Consideration on Point Light Source and Grey Scale Rendering

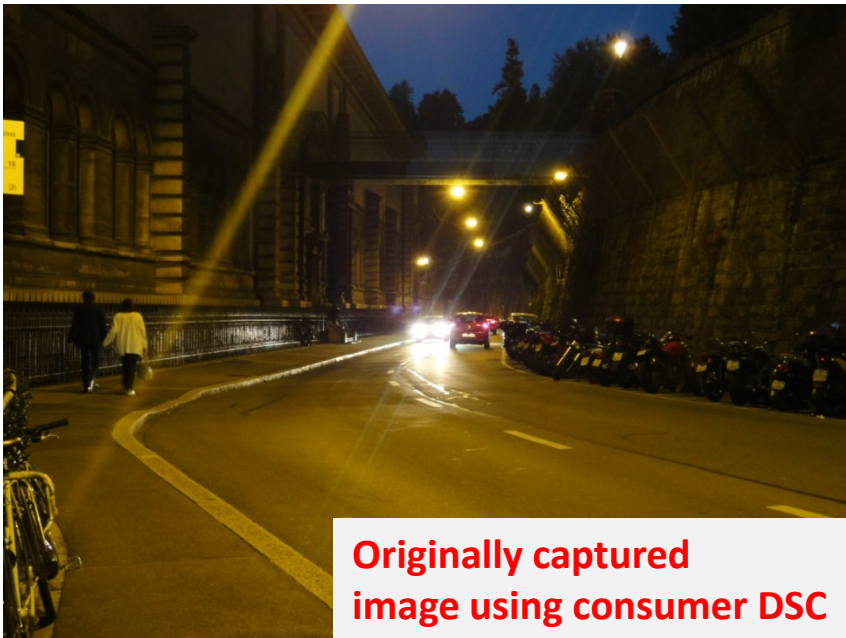
Loss of road environment perceptibility caused by strict requirements on PLSDF.

The slide shows some image examples resulting of camera adjustment to satisfy strict PLSDF requirement, which is presently proposed for adoption within UN Regulation 46 as a requirement for CMS.

The proposed PLSDF value only evaluate the system from one specific aspect, in which it gives priority to observe the point light source in interest as an absolutely separated two point light source.

If strict requirement is imposed on PLSDF value, the CMS will have to adjust the operation of the system to show images like in the example shown at upper left image. **The driver loses a large amount of safety relevant visual information which is essential in the scene interpretation and decision making, by doing so.** Example of an urban scenario in Tokyo.

Another example of urban scenario where pedestrian get lost if adjusted to meet PLSDF high requirement.

It is therefore suggested that in case a “strict high requirement on Point Light Source” is an indispensable requirement at specific driving scenario, the adoption of the requirement is made such that the CMS is adjustable to have a manual or automatic operation mode where CMS satisfy the above strict high requirement on Point Light Source.

CMS shall be adjustable whether manually or automatically, such that an operation mode is reserved to satisfy the PLSDF>[TBD], according to test method and condition as described in Annex 12, paragraph XX[to be created].
